Technical Service Bulletin

SQUEAK NOISE FROM FRONT BRAKES AND/OR GROOVE MARKS ON FRONT DISC PLATE

Bulletin No.: 04-002/17

Last Issued: 02/17/2017

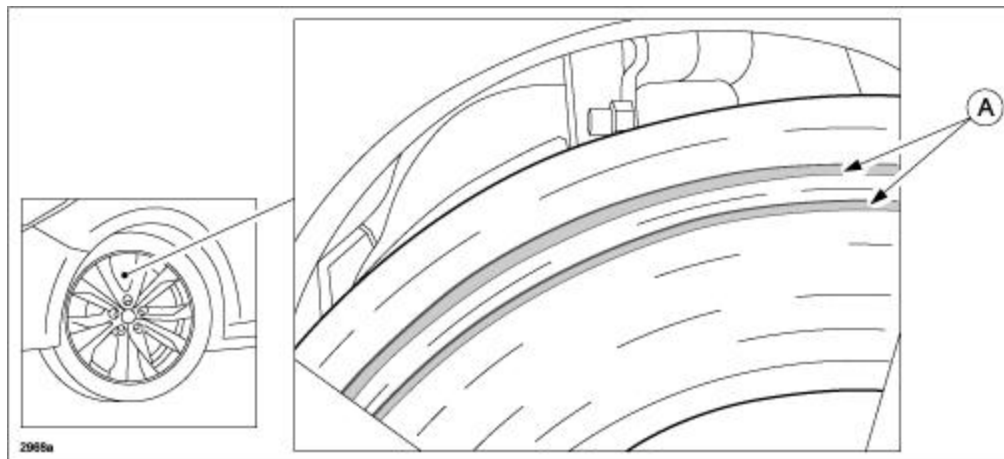
Some vehicles may exhibit a squeak noise when applying the brakes and/or groove marks (A) on the front disc plates. This is caused by abrasive metal from the front disc plate sticking to the brake pad, which damages the disc plate over time. To correct the problem, a modified brake pad is being used.

Front Brake Pads

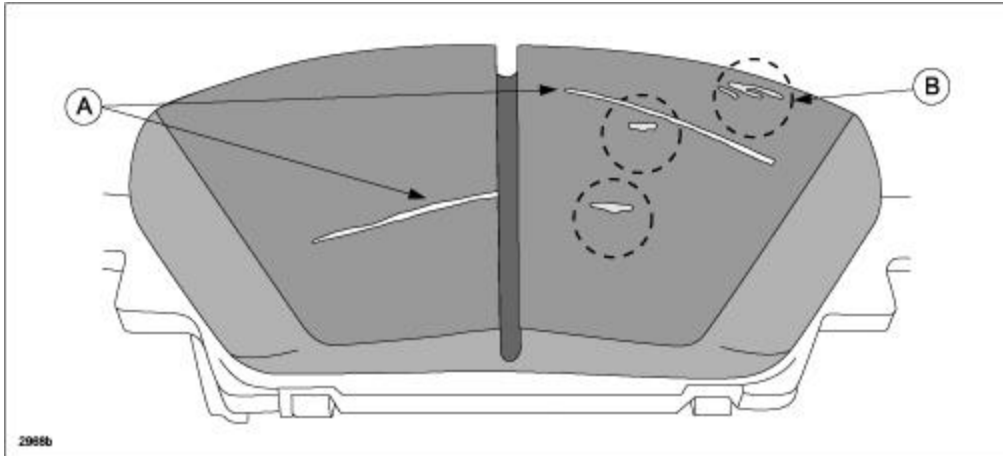
Visually inspect the front brake pads surface for pieces of metal.

- If metal pieces (silver or white in color) are found in a line (A) or cluster form (B) on the surface, replace the front brake pads with a modified service set.

Front Disc Plates

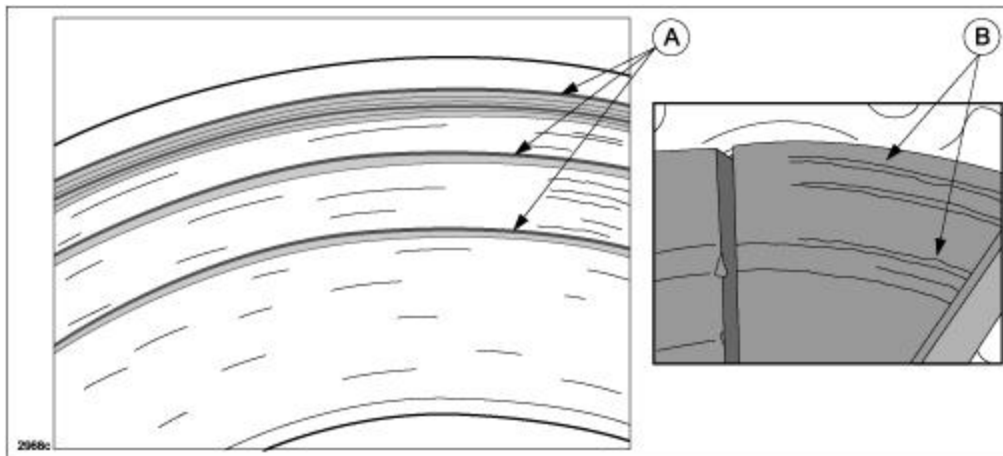
Visually inspect the surface of the disc plate(s) for damage.

- If groove damage is found on a disc plate (A) and brake pad (B), replace the front brake pads with a modified service set and **ONLY** the damaged disc plate(s).

NOTE: Metal may have dropped off the brake pad, and groove damage will be found on the brake pad in the same position as damage on the disc plate.
